United States Patent and Trademark Office

| APPLICATION NO. | | ILING DATE | FIRST NAMED INVENTOR | ATTORNEY DOCKET NO. | CONFIRMATION NO. | |
|-----------------|------|------------------------------|----------------------|---------------------|------------------|--|
| 10/696,214 | | 10/28/2003 Kiri B. Amarakoon | | D/A2518 | 7332 | |

DETAILED ACTION

FIG. 1

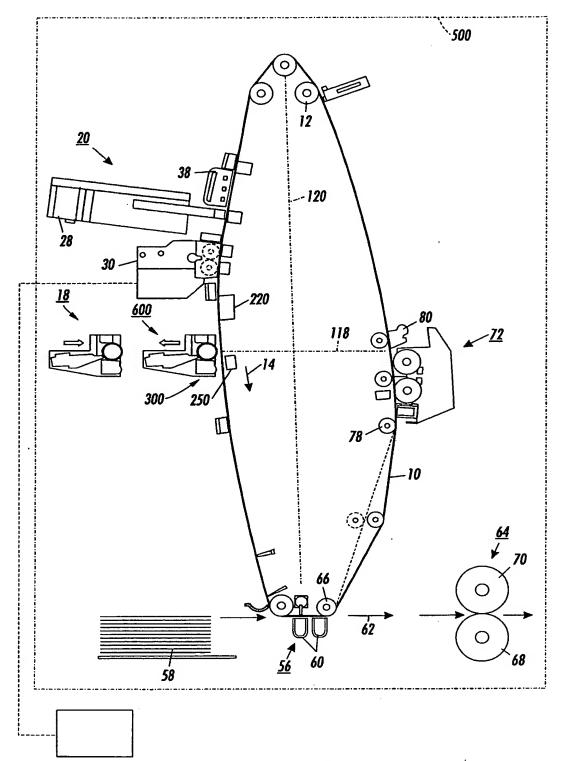
- 3. The drawings are objected (secondly) to as failing to comply with 37 CFR 1.84(p)(5) because they include the following reference character(s) not mentioned in the description: 38 (Figure 1). Corrected drawing sheets in compliance with 37 CFR 1.121(d), or amendment to the specification to add the reference character(s) in the description in compliance with 37 CFR 1.121(b) are required in reply to the Office action to avoid abandonment of the application. Any amended replacement drawing sheet should include all of the figures appearing on the immediate prior version of the sheet,

4. The drawings are objected (secondly) to as failing to comply with 37 CFR 1.84(p)(4) because reference character "500" has been used to designate both "an image forming apparatus" (Figure 1) and "a module" (page 5, paragraph [0015], line 1, etc.). Corrected drawing sheets in compliance with 37 CFR 1.121(d) are required in reply to the Office action to avoid abandonment of the application. Any amended replacement drawing sheet should include all of the figures appearing on the immediate prior version of the sheet, even if only one figure is being amended. Each drawing sheet submitted after the filing date of an application must be labeled in the top margin as either "Replacement Sheet" or "New Sheet" pursuant to 37 CFR 1.121(d). If the changes are not accepted by the examiner, the applicant will be notified and informed of any required corrective action in the next Office action. The objection to the drawings will not be held in abeyance.
